Linden
scheme Norton Road, Thurston
(Phase 2) - 171 Units
client: Linden (Thurston) LLP
drawing: Soft Landscape Proposals
date: April 2020
scale: 1:200@A1
drawing no: LN22824-13A (Sheet 7 of 13)
drawn: IS checked: HCS

Linden
scheme Norton Road, Thurston
(Phase 2) - 171 Units
client: Linden (Thurston) LLP
drawing: Soft Landscape Proposals
date: April 2020
scale: 1:200@A1
drawing no: LIN22824-13A (Sheet 5 of 13)
drawn IS checked HCS

scheme Norton Road, Thurston
(Phase 2) - 171 Units
client: Linden (Thurston) LLP
drawing: Soft Landscape Proposals
date: April 2020
scale: 1:200@A1
drawing no. LIN22824-13 (Sheet 3 of 13)
drawn: IS checked: HCS

Sheet 7

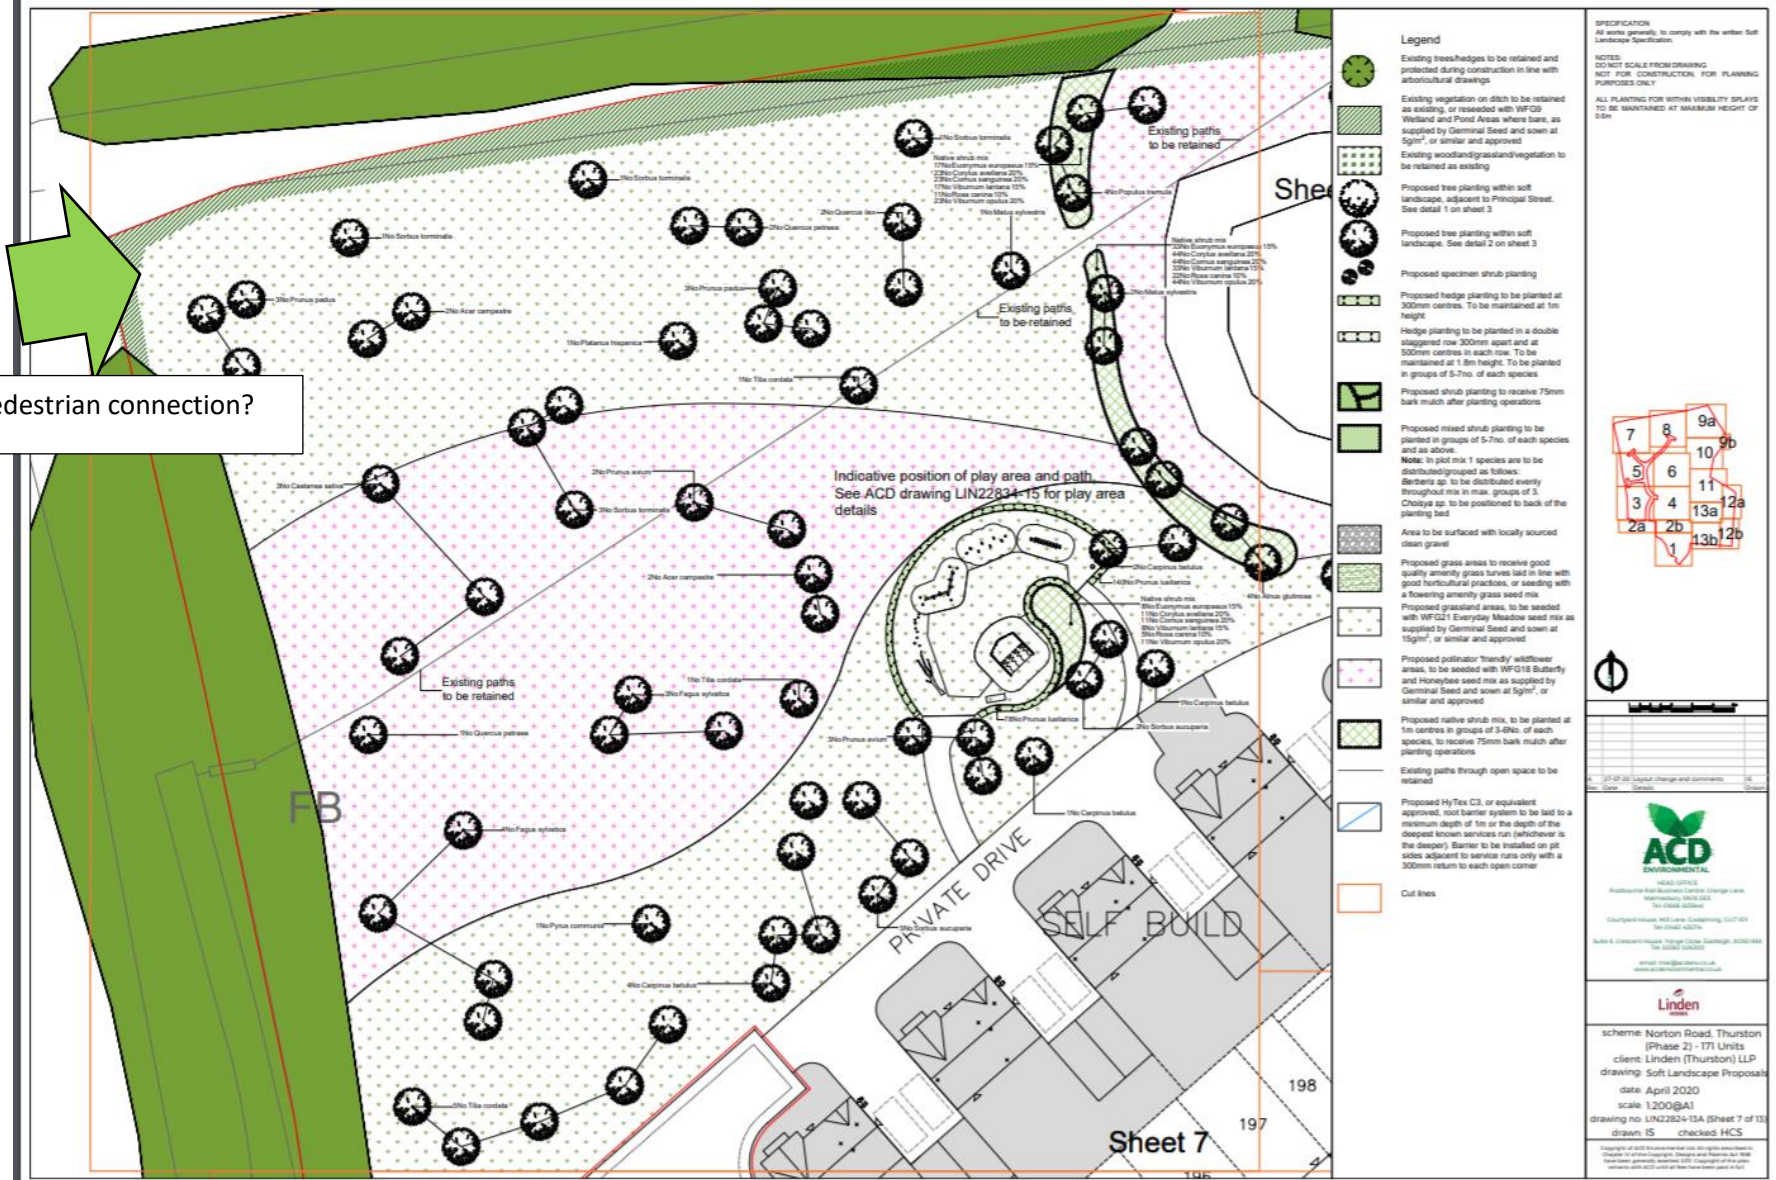
Legend needs to state whether bold green = retained flora

Possible pedestrian connection?
